EAGLE MOUNTAIN CITY
PLANNING COMMISSION MEETING AGENDA

TUESDAY, JUNE 24, 2014 AT 6:00 P.M.

Project: Oquirrh Mountain Master Development Plan – Master Development Plan Amendment

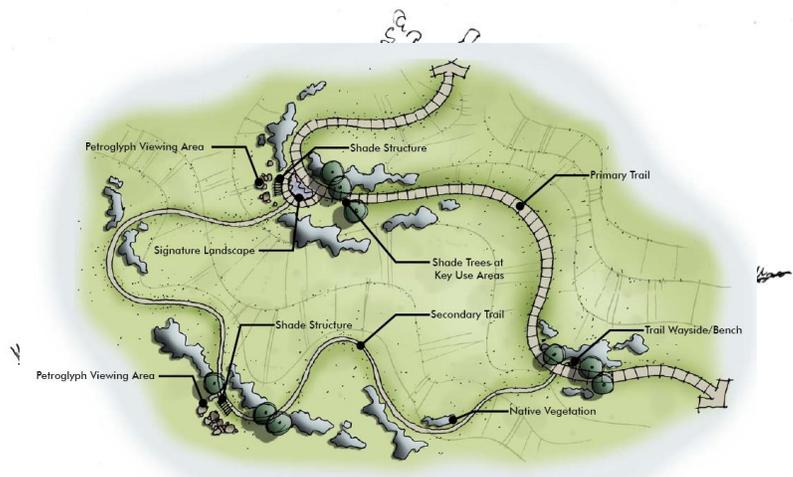
The Conceptual Site Plan that is included with this application is conceptual only and is not tied to the Master Development Plan Land Use Element approval. It can be included as an exhibit to the Development Agreement as an example of the mixture of housing types and style of development, but will not be used to dictate layout of buildings, etc. The in details of the site layout are illustrative only, and it may change in the future.

The plans show a 3.3 acre church site in the southeast corner of the property. Previously, at the City's request, the applicant had placed a planning area designation (including density and total units) on that site. The purpose of this was to prevent requiring the applicant to amend the master plan if the church decided not to purchase the property, while still providing vesting for future development should the sale not occur. As the 3.3 acre site has been sold to the church, the density cannot be transferred to other units. Thus, the applicant has removed the density for the church site from the proposed master plan.

Oquirrh Mountain Master Development Plan

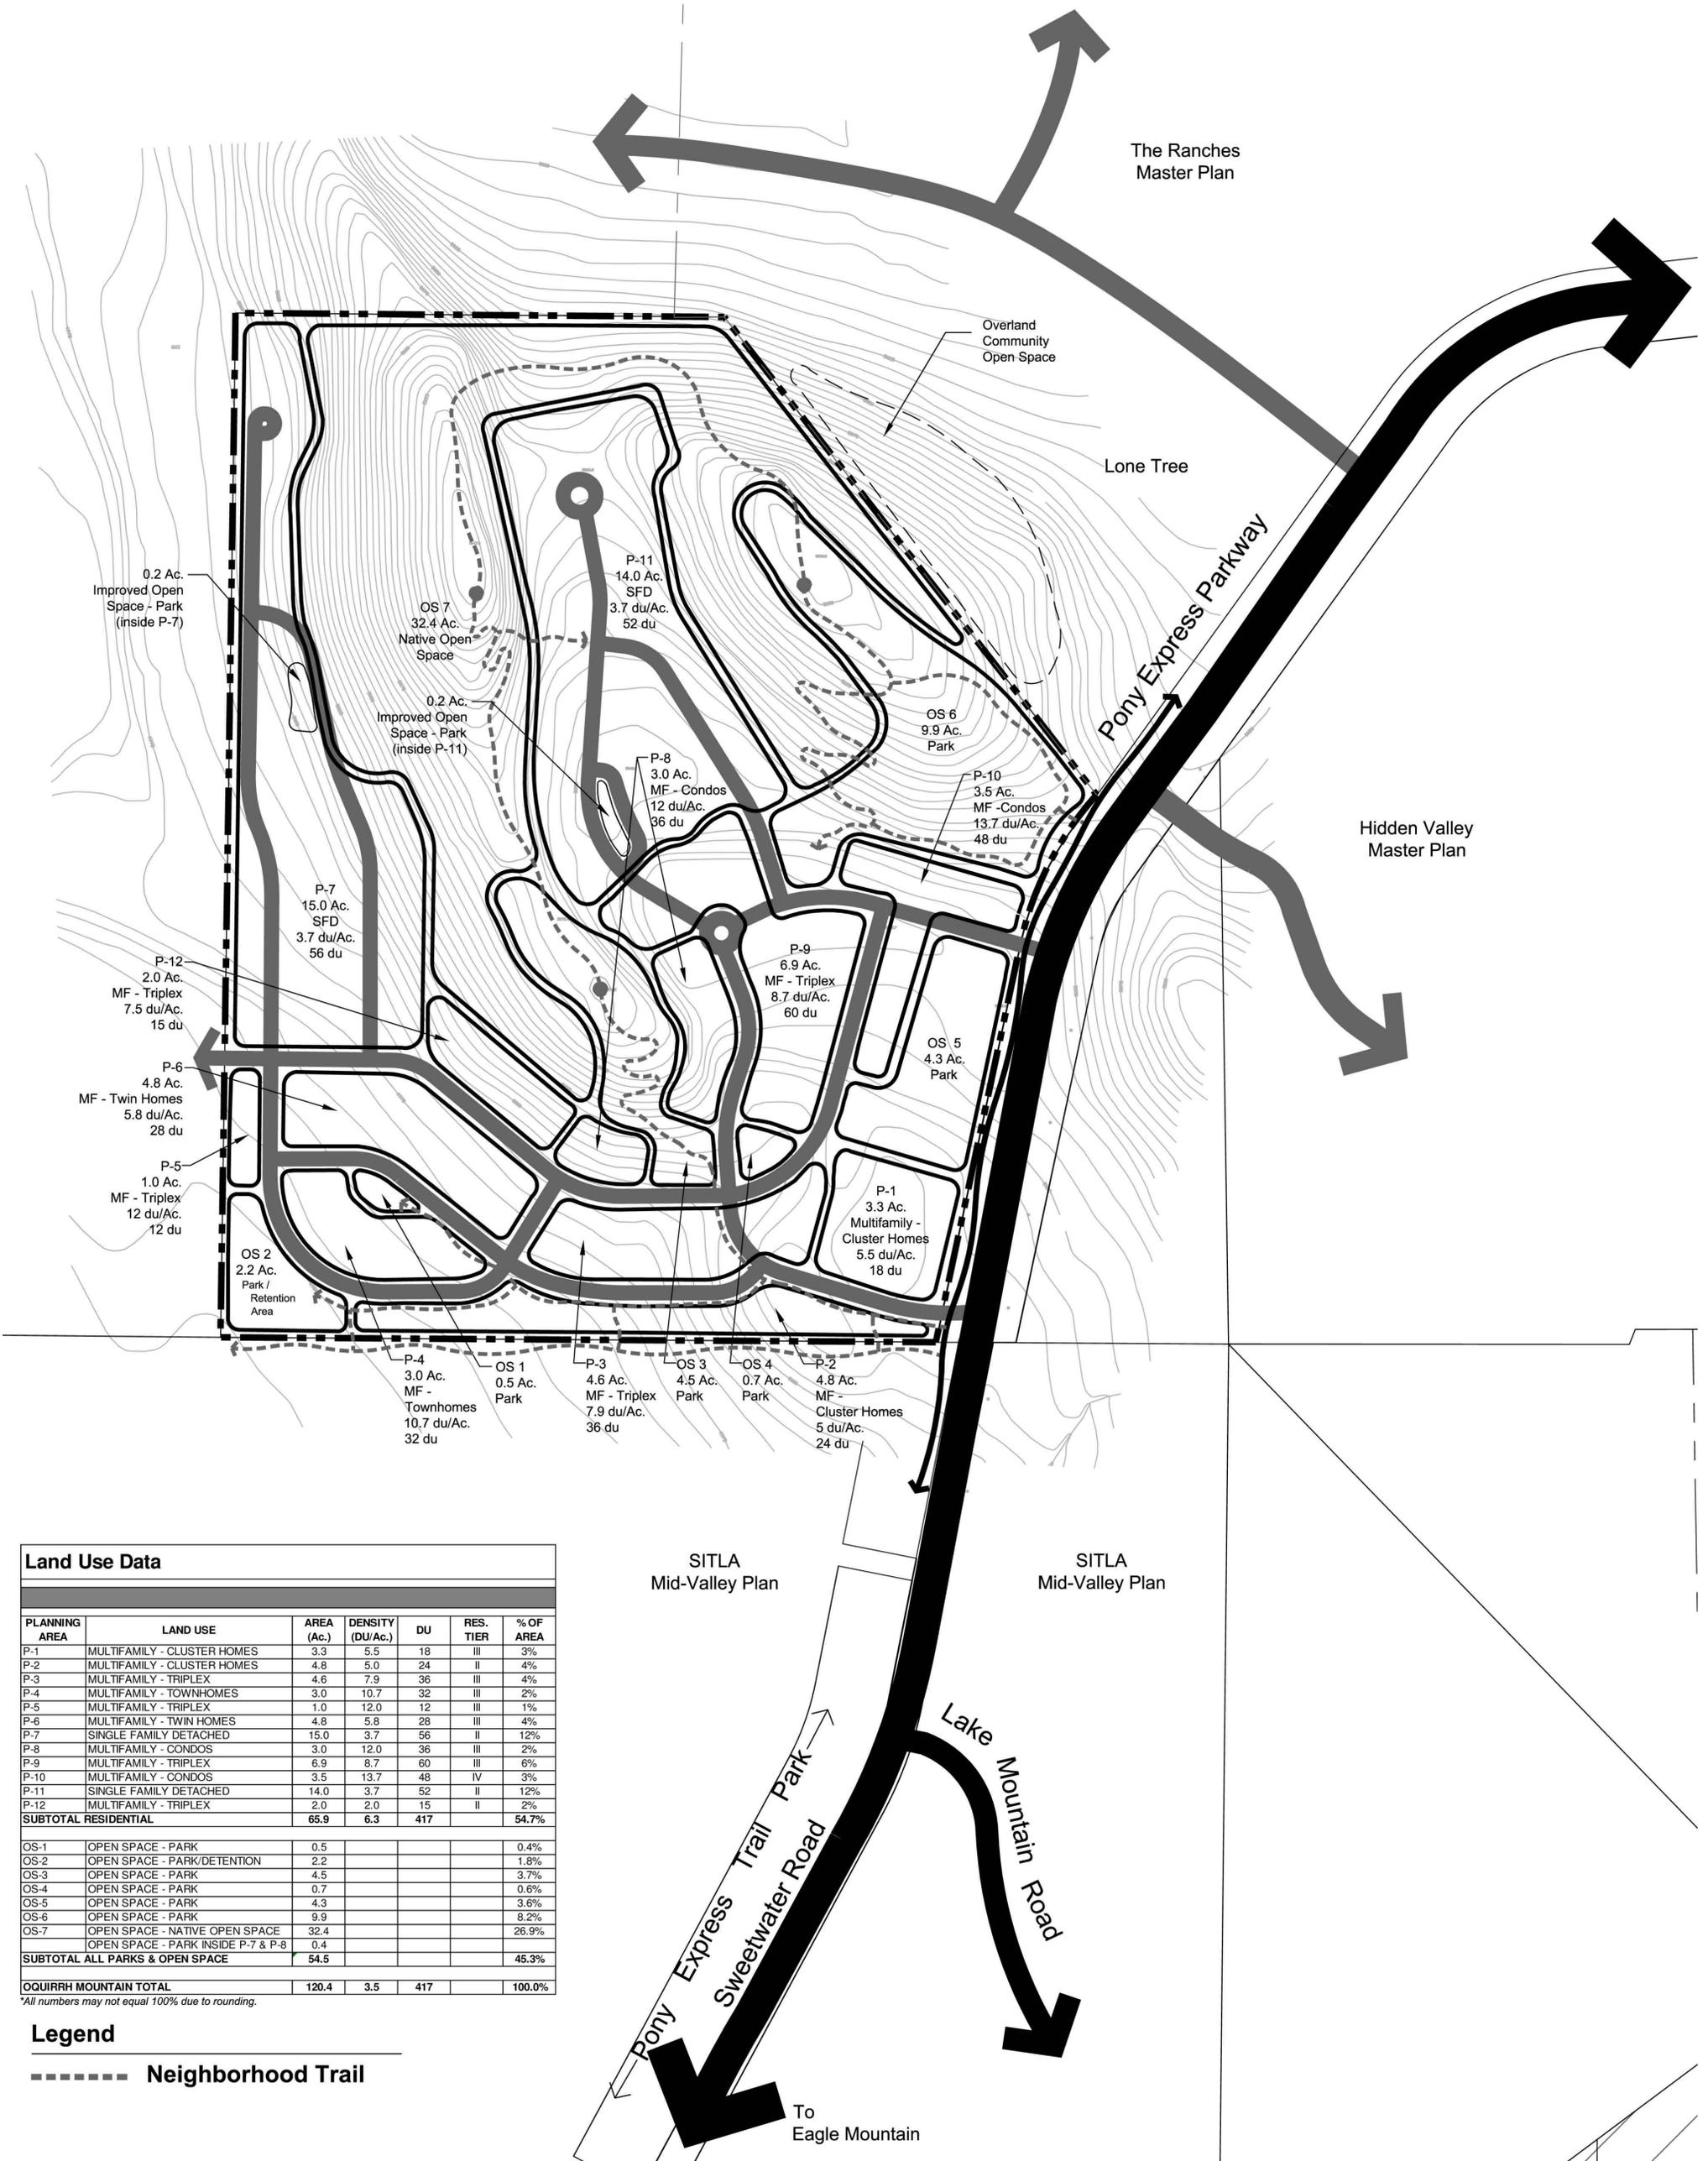
This project is required to provide 10.228 acres of improved open space according to the Bonus Density chapter of the Development Code (The Parks and Open Space Plan land use data table should be changed to agree with that number). The definition of "improved open space" is stated in the Dev. Code as the following, "Area that has been improved and landscaped as approved by the City. This area may include trails, parks, and other amenities." It is the City's Development Review Committee's opinion that the park, recreation, and trail systems proposed, while unique and different than the standard open space requirements in the Development Code, meet the required 10.228 acres of improved open space. The applicant has moved the large (4+) recreation field to an area previously designated for townhomes. The new area 'OS-1', a 3.5 acre park area has been reconfigured to include an all-purpose ball field, tennis courts and a community swimming pool.

The various park and amenity designs and plans submitted with the original master plan are retained in the amended plan. Seeing as these are being presented as key components of the overall park and open space system, these plans should be retained as exhibits to the amended master development agreement and referenced in the approval of this master plan amendment. We can then use these plans in the future to guide the park development when individual site plans and plats are developed. These plans would still be flexible, but the quality, creativity, and key elements of the design could be dictated in the plans.

other. The applicant should provide some justification for this placement and their compatibility or revise the plans to make it more compatible.

12. EXTERNAL COMPATIBILITY. 20-foot setback to be added along the southern boundary. This 20-foot building setback is to include a 10-foot landscaped corridor on the applicant's plans and plats – to be one-half of a 20-foot corridor to be cooperatively planned with SITLA, which will provide both the other 10-foot landscaped portion of the corridor and the trail.

13. PETROGLYPHS. The petroglyphs shall be protected and preserved.
14. INTERNAL COMPATIBILITY. P9 to P11 (original plan, now areas PA-11, PA-9a, and PA-11B) compatibility to be resolved to Planning Staff's approval.
15. AMENDED MASTER DEVELOPMENT AGREEMENT. The Amended Master Development Agreement must be approved by the City Council and signed by the applicant for this approval to be valid.
